# Sharalyn Fraser *Agency*

# Code Compliance Certificate

| Street Address    | 131 King Arthur Drive, Paraparaumu     |
| Proposal          | New Dwelling                           |

Drawing Title:  
DRAINAGE PLAN

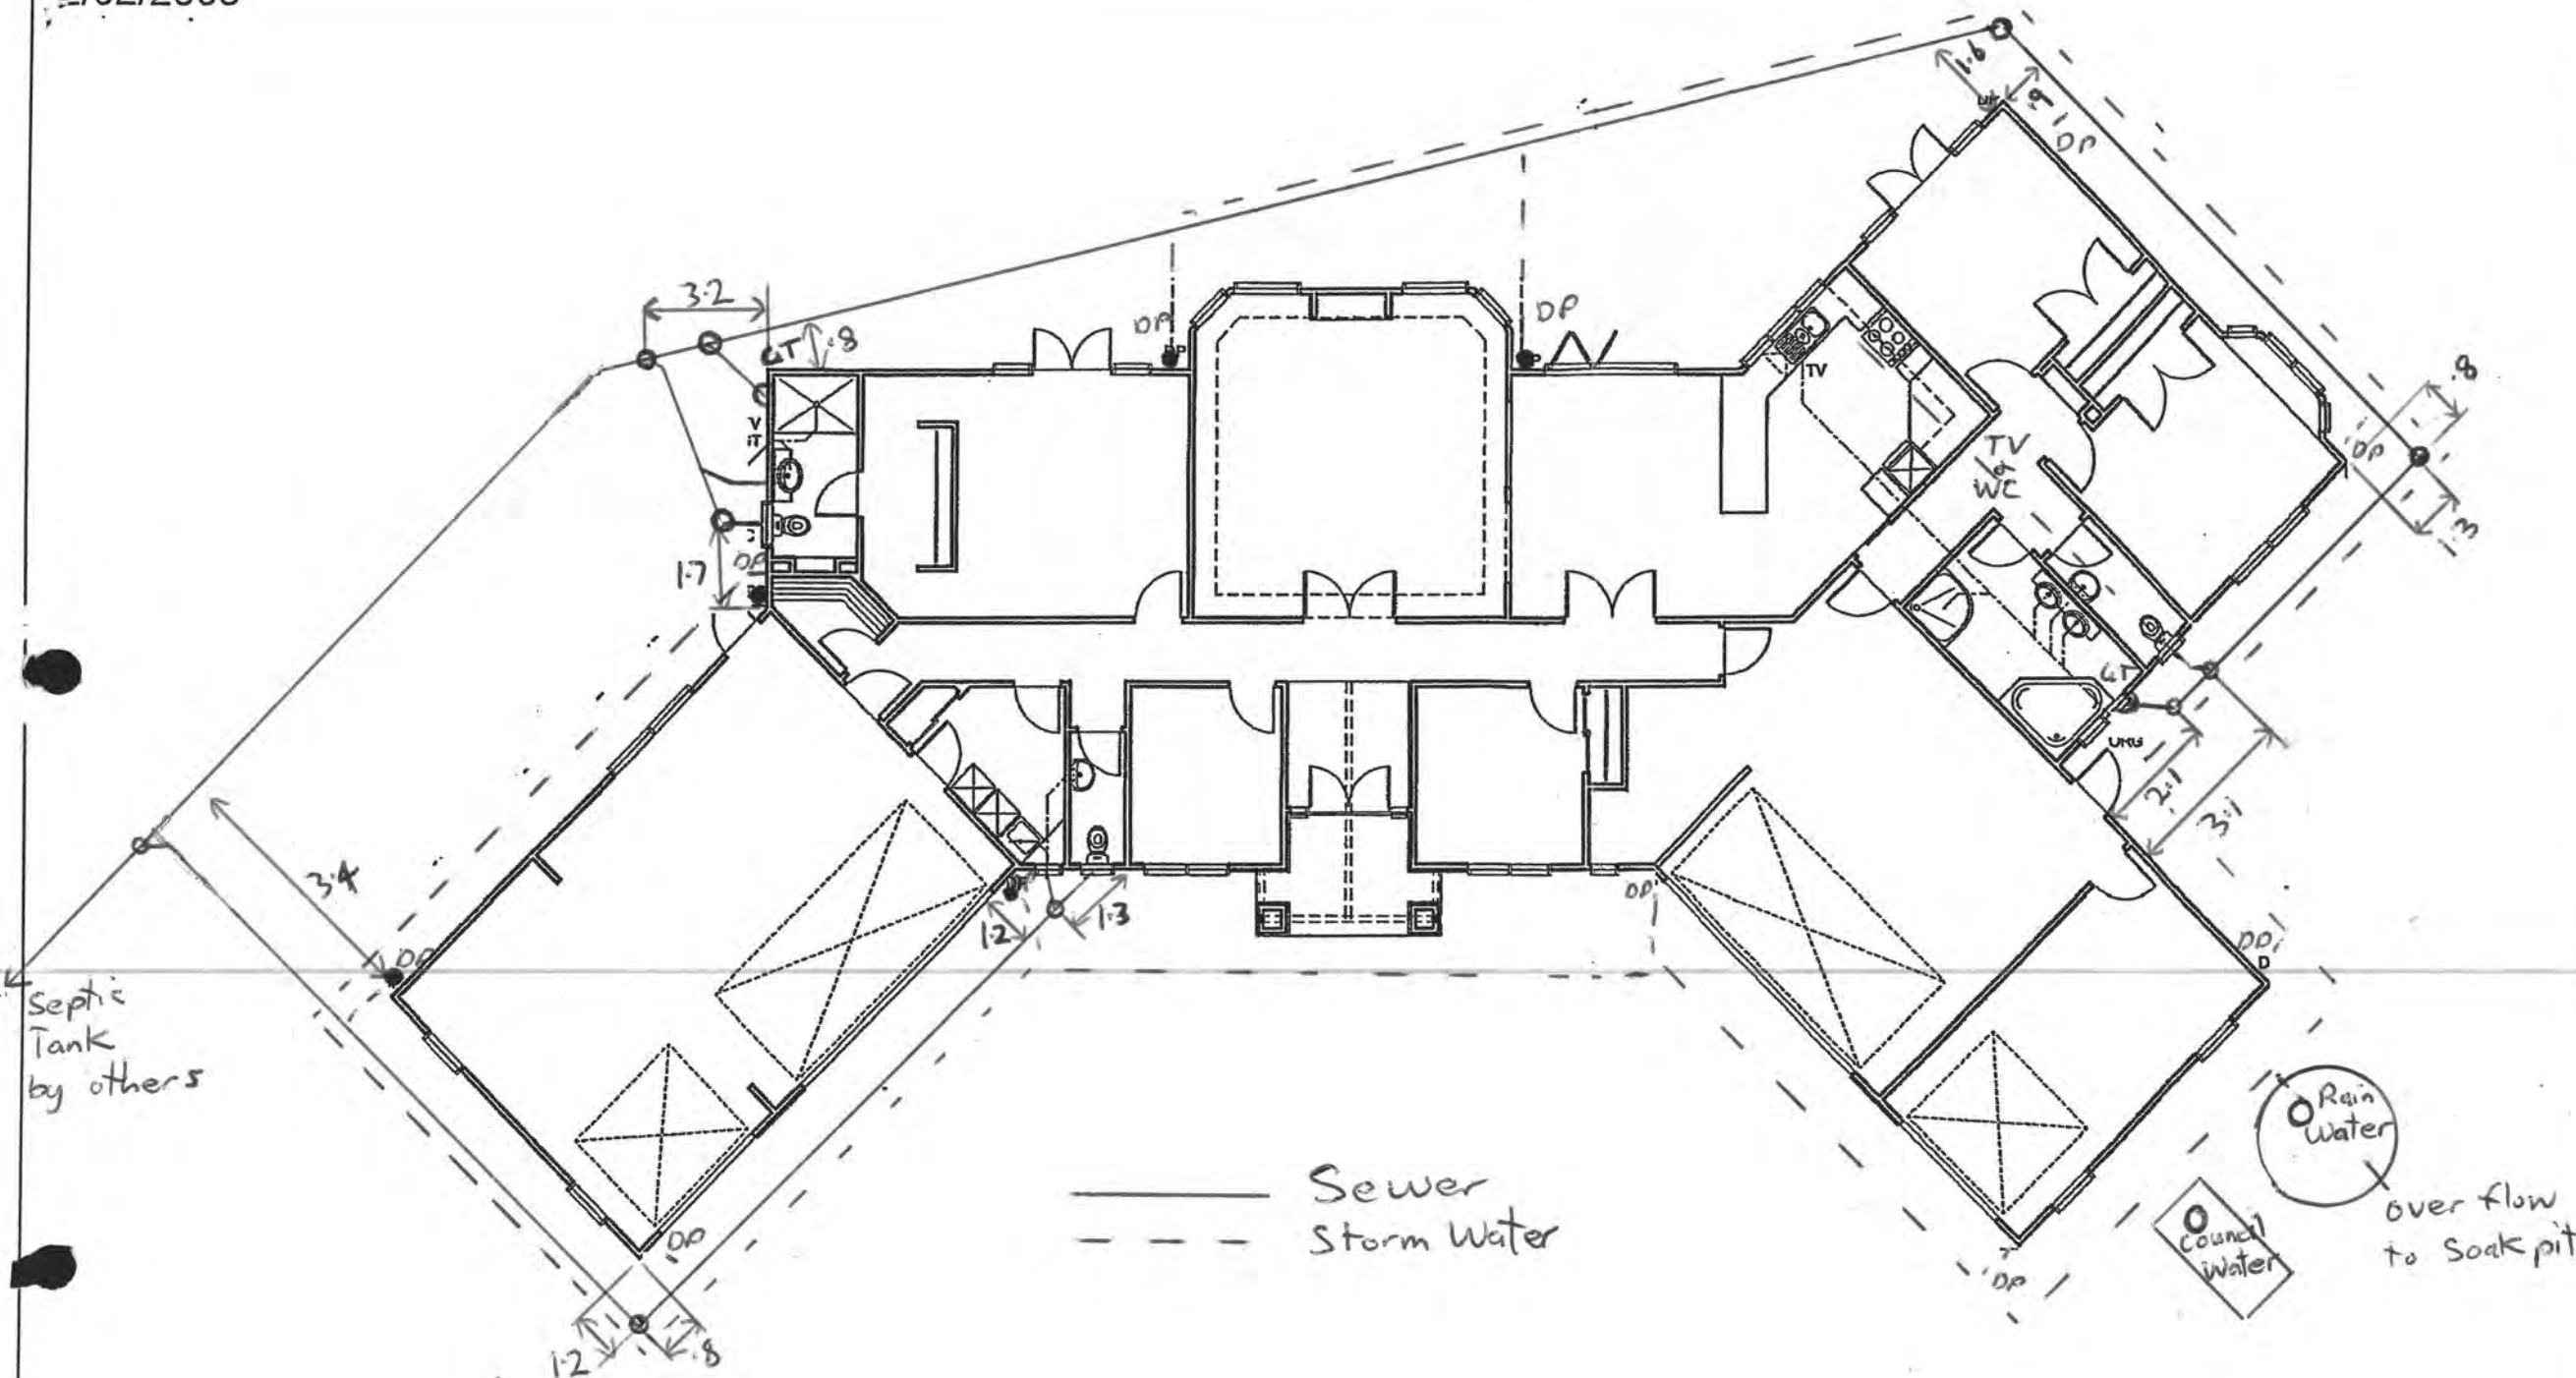
Please show under slab drainage, stormwater  
, sewer and watermain and toby location on the asbuilt plan  
provided to Council.

Drawing Title:  
 DRAINAGE PLAN

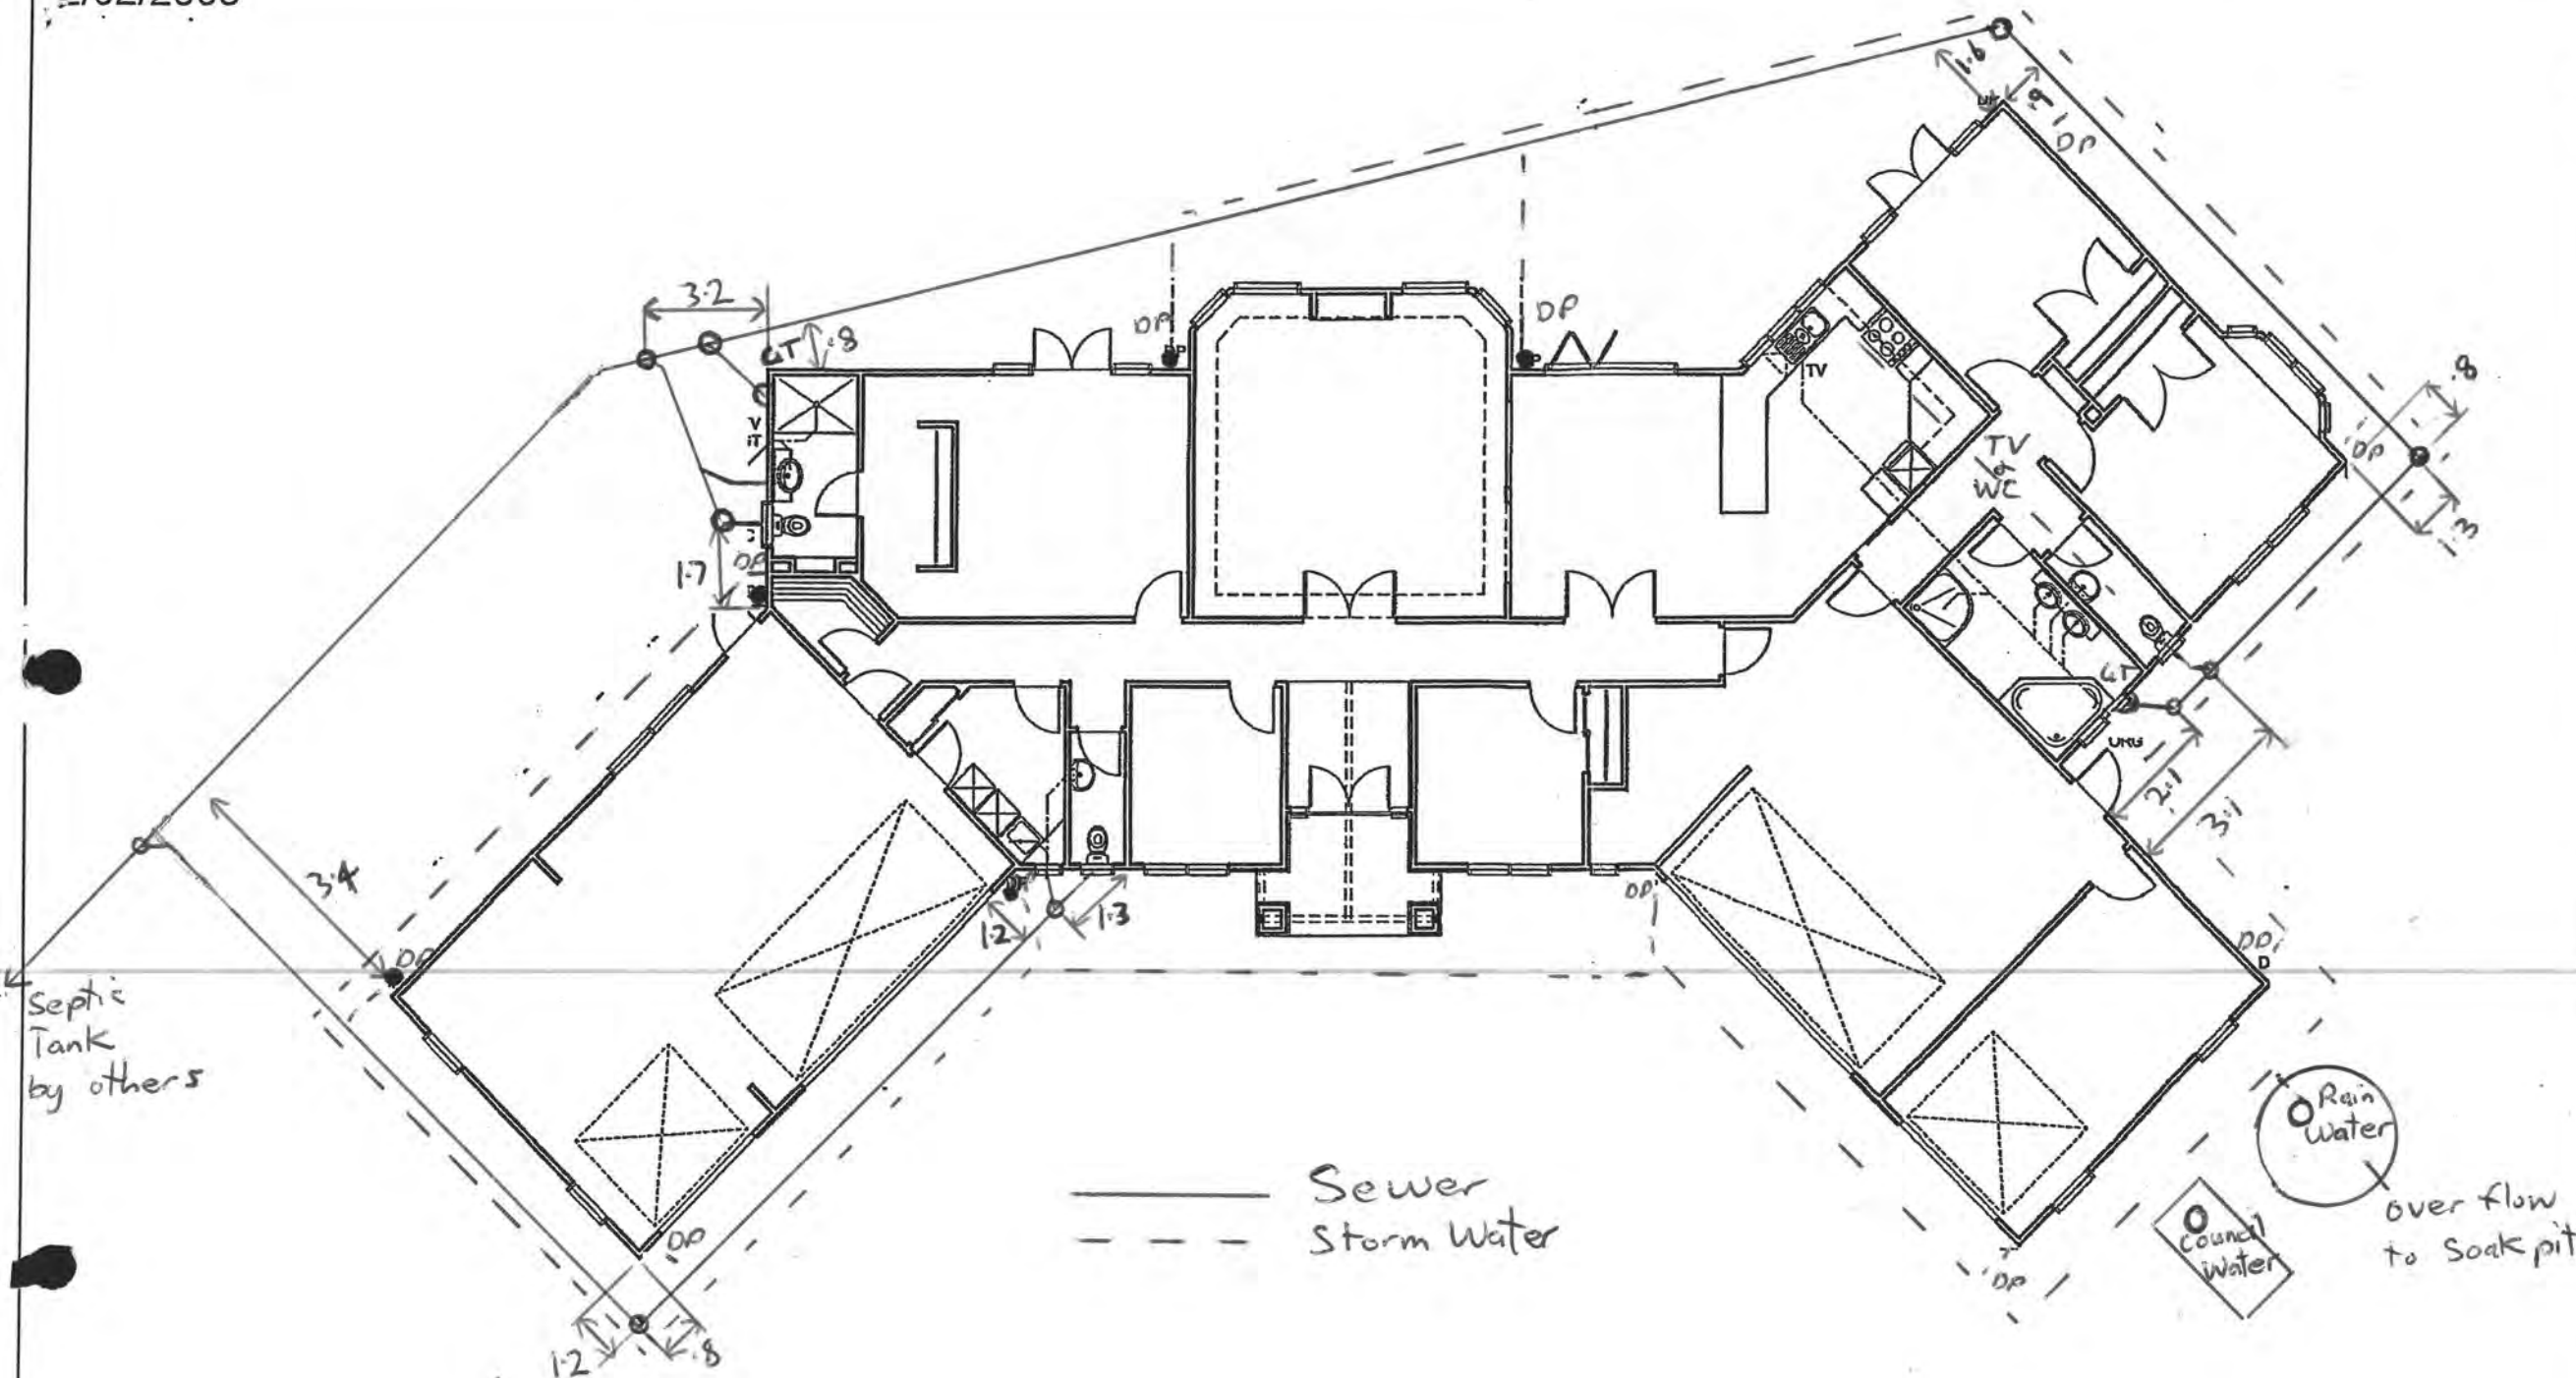
Please show under slab drainage, stormwater  
 ,sewer and watermain and toby location on the asbuilt plan  
 provided to Council.
